802.3dj D3.1

Comment Resolution

Optical Topics

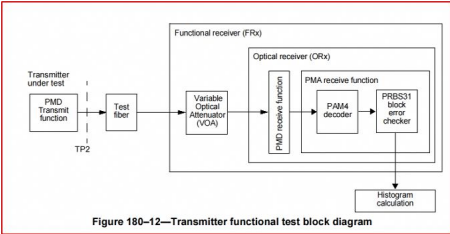
This says "the best estimate of the actual MPI and DGD penalties of the test fiber", yet the fibre alone doesn't make much MPI. The reflections between transmitter and connectors, and receiver and connectors, are more important. It is not clear which reflections are taken as baseline and which are attributed to the fibre, particularly as both transmitter and receiver reflectances are not necessarily at the spec limits. MPI varies with polarisation yet there is no polarisation control in Figure 180-12.

If the TFT section is kept;
if MPI penalty variations are important, explain how the MPI penalty is to be estimated and add polarisation control. If MPI penalty variations are not so important or not feasible to estimate with confidence, use a fixed allocation

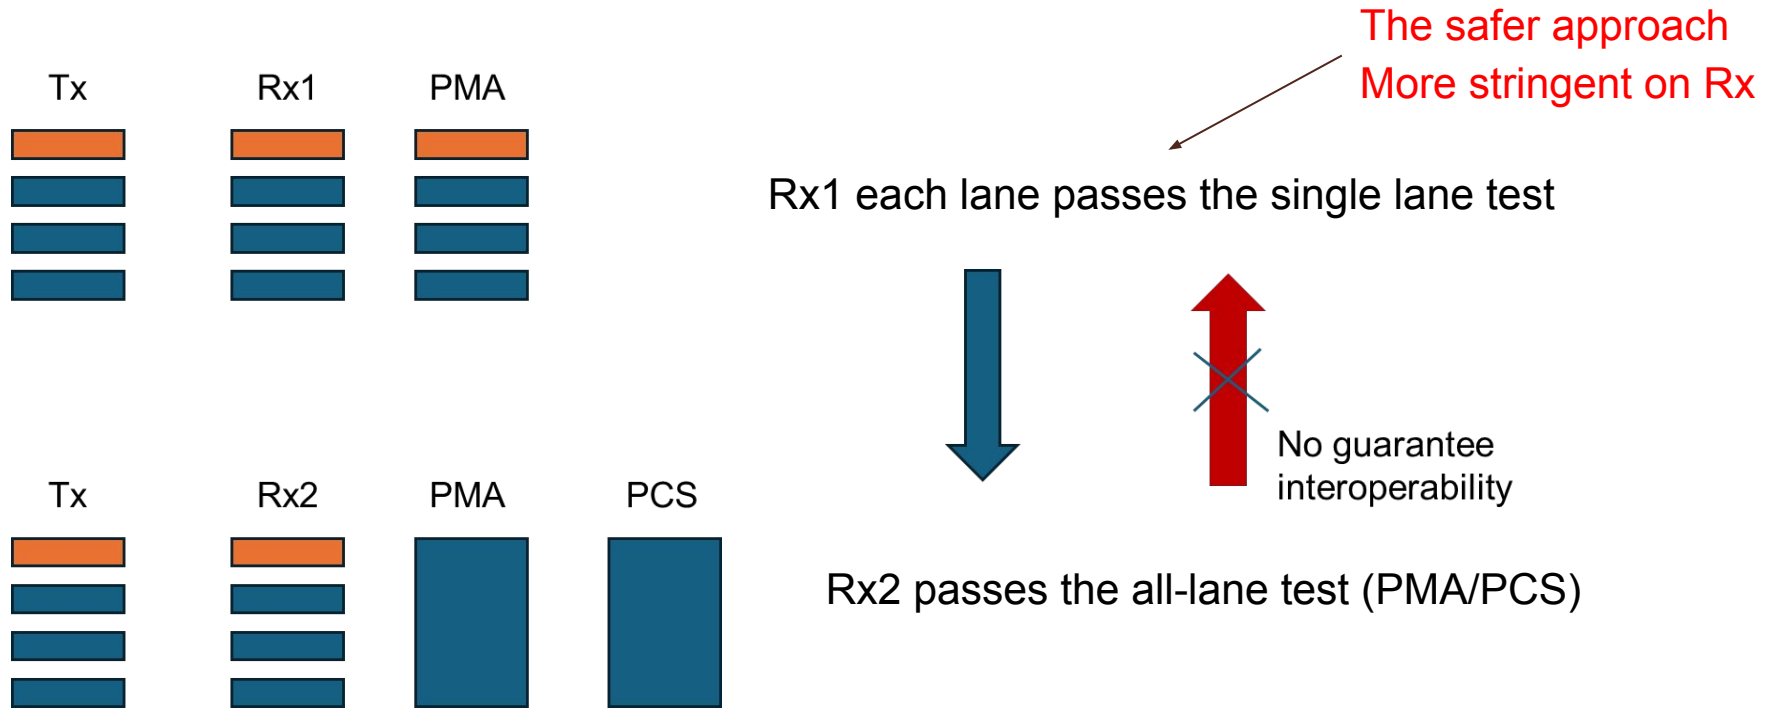
This comment is in support of comment i-493 against D3.0. For a multilane system what matters is the Frame Loss Ratio of the interface which is a function of the performance of all the lanes. It is not necessary for all the lanes to meet the specification here. Also it is not possible to test the performance of the individual lanes when using scrambled idle (pattern 5). Also the test method called out in 174A.9.6 (allowed by page 492 line 2) specifically allows is a multilane test.

Delete "of each lane" here and for stressed sensitivity on page 493 line 37. Make the equivalent changes in clauses 181, 182, and 183 (note that the change is not needed in 181.9.15 or 183.9.15 as they already do not say "of each lane". If the committee decision is that all lanes must meet the specification individually then pattern 5 needs to be removed as a test pattern option, 174A.9.6 needs to be deleted and exceptions need to be made to 174A.9.5 and 174A.9.7 which allow the use of 174A.9.6.

Implement the following changes:

delete pattern 5 from test pattern specified for receiver sensitivity and Stressed receiver sensitivity in Table 180-13.

delete reference of 174A.9.6 from the receiver sensitivity methodology.

Delete the note that begins with "When measuring receiver sensitivity of a complete PHY at the PCS...."

Add an exception in 180.9.14 and 180.9.15 that, when testing using 174A.9.5 or 174A.9.7, the compliance may not be further verified using 174A.9.6.

BLER test method for all lanes 174A.9.6

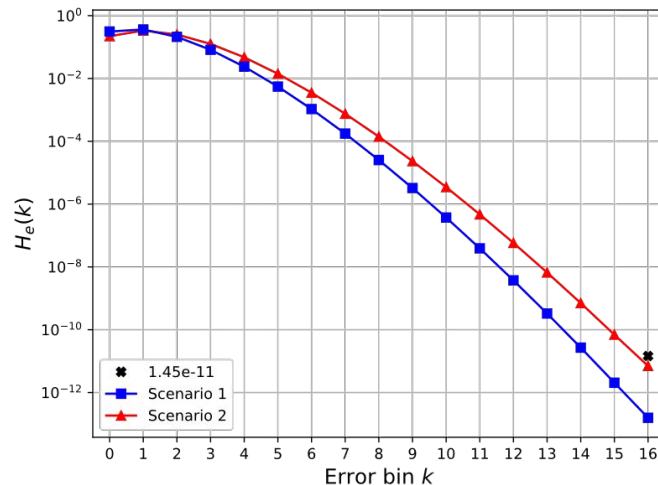
Assume four optical lanes 0,1,2,3, consider two scenarios:

1. BER over four lanes is [3e-4, 1e-4, 1e-4, 1e-4]
2. BER over four lanes is [2.5e-4, 2e-4, 2e-4, 2e-4]

Calculate $H_e(k)$ with $BER_{added} = 6.4e-5$, and compare $H_e(16)$ with $1.45e-11$

Both scenarios pass the test method for all lanes, but with $BER > 2.28e-4$ for lane 0.

Propose to use only the per-lane test method for receiver sensitivity, and define receiver sensitivity as per-lane property

Figure 180–9—TDECQ conformance test block diagram

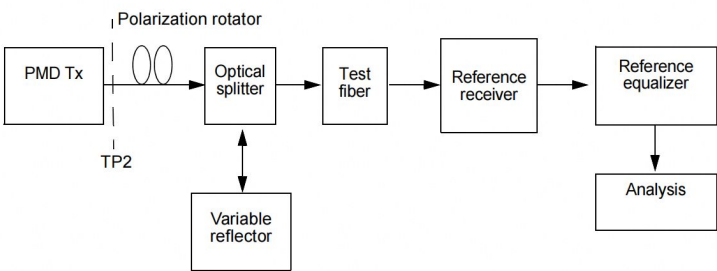
Repeating description of polarization.

The channel provides back reflection with return loss specified in Table 180–15. The state of polarization of the back reflection is adjusted to create the greatest RIN.
